Agency: U.S. Nuclear Regulatory Commission

Title: New Hampshire Yankee Presentation to NRC
Staff on Pullman-Higgins Field Weld Records
Re-Verification Project

DATE: Wednesday, April 10, 1991

RH-M-1
LATER
NA

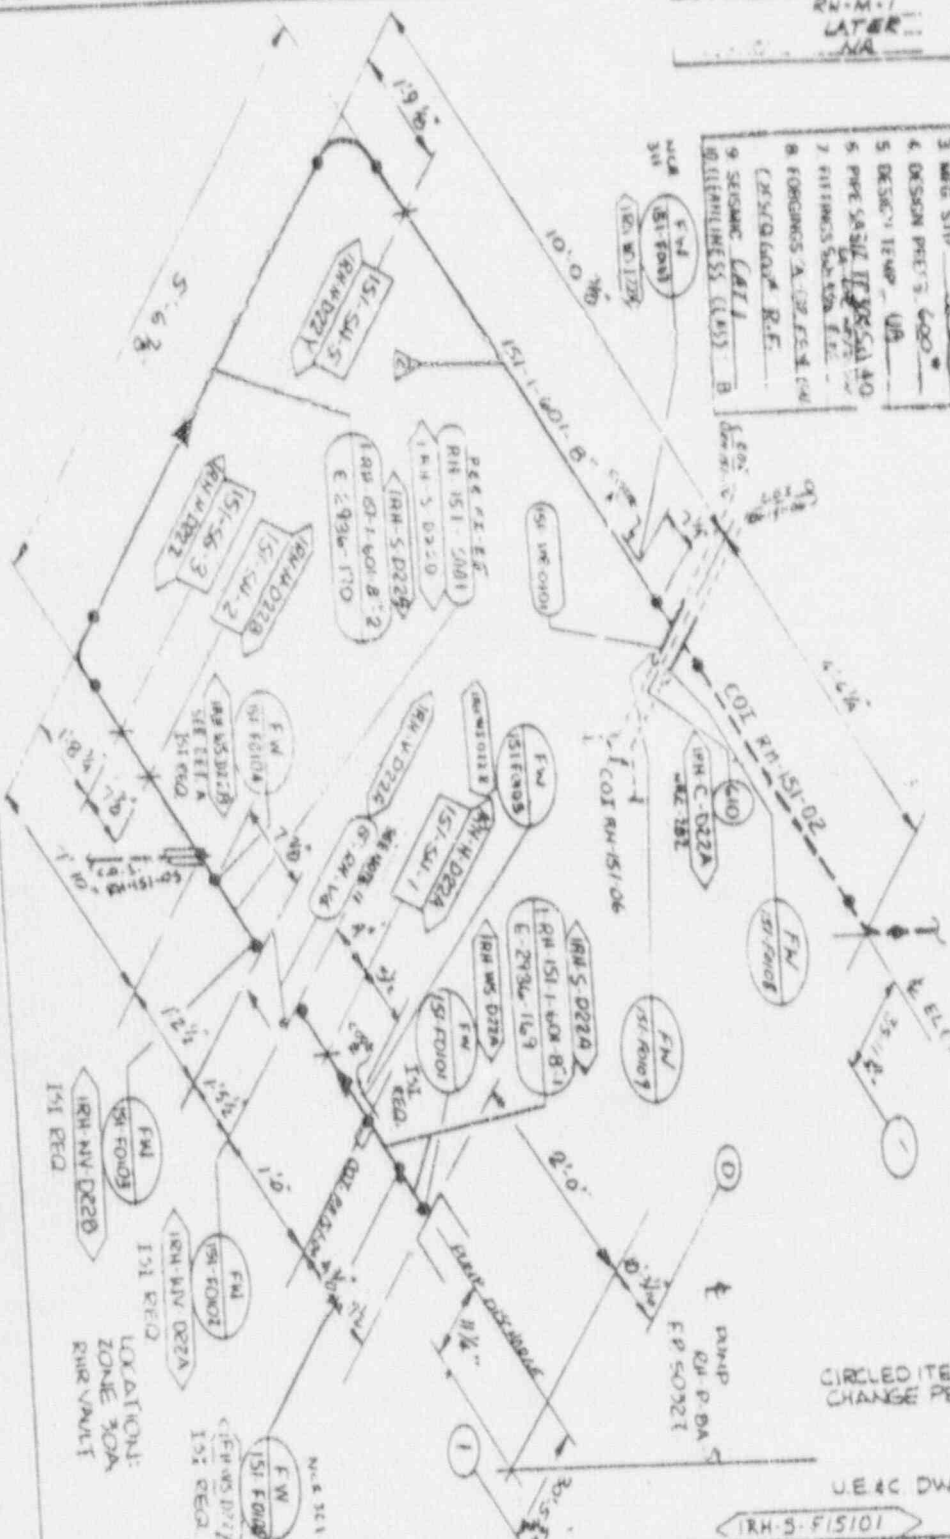
4 MR. SNIEZEK: The question on the methodology.
5 When we looked at the second isometric, the one that had th
6 verbiage on it, when the contractor picks the welds that
7 require radiography, are they just taking the weld numbers
8 off the ISO sheet as they are listed?

17 MR. CERNE: Okay. So going back to Mr. Snizek's
18 question, they are in fact looking at not only the ISOs
19 forward, but the ISOs back? In other words, if the ISOs ar
20 specifying the correct type of NDE or the type of weld that
21 is listed?

1 are butt welds and the field welds that are fillet welds,
2 and you won't be doing any research to verify whether those
3 classifications are correct. The only time you will be
4 doing any research to determine if there was a question is
5 if those specifications weren't on the ISO?

7 MR. BATEMAN: Okay. So I think the answer to Mr.
8 Sniezek's question is for those ISOs that have the
9 information on them, you're not going to be verifying that
10 the information is accurate?

13 The reason I ask the question is the ISOs will be
14 out of your files, and any design modifications that were
15 made, your assumption is that what you have before you
16 accurately represents the as-built condition?

18 When people -- when the TASK 1 contractor
19 researches isometric drawings, will they be using only the
20 material in the blocks that designate the field welds, or
21 will they instead start with the actual line designations,
22 the piping drawing, counting the welds, and then
23 determining, for example, there are ten welds in this
24 system, looking at line sizes to see if it makes sense with
25 respect to the Code, that these are fillets, that these are

5 MR. CERNE: Well, I guess the question comes up,
6 if, you know, the purpose of the charts showing that what
7 the code requires radiography is meaningless to these
8 individuals, that all they have to do is look at the
9 Pulmann-Higgins block and say this is what requires
10 radiography, knowledgeable people, we would assume, would be
11 able to determine where they have before them the contract
12 requirements and the code requirements, and they are
13 knowledgeable, they would be able to determine where the
14 isometric drawings may be in error, minus a field walkdown.

15 If a person is unable to determine from the
16 isometric drawings, that's one thing, but if somebody shows
17 a six-inch weld at the socket weld or the fillet weld where
18 there's a six-inch pipe, then we would expect knowledgeable
19 people to question that.

20 MR. DESMARAIS: They will also review any design
21 change documentation that has not been incorporated in a
22 particular isometric.

23 For example, there may be an engineering change
24 authorization that has not been incorporated in one of the
25 revisions. They will review all the outstanding design

1 change documents that existed against this document, the
2 isometric, at the time it was turned over for completion of
3 the N-5 process.

15 MR. DESMARAIS: The starting point would be the
16 isometric, the actual configuration of the piping as
17 depicted on the drawing.

18 The second step would be to review any outstanding
19 and varying documentation that exists that hasn't been
20 incorporated on the drawing.

23 The fourth step would be to use existing
24 information that currently exists on the isometric and/or i
25 the design change documents that would indicate the type of

1 radiography requirements that may be or may not be invoked
2 - for instance, the non-destructive examination requirement
3 for the welds, staying squarely within the four corners of
4 the isometric and existing change documents.

21 MR. FEIGENBAUM: That's not unreasonable. No, it
22 would be questioned, and that would be part of the effort.
23 And certainly if there is no -- the type of weld was not
24 specified, there would be a thorough review back through the
25 code requirement as to what weld type was required and
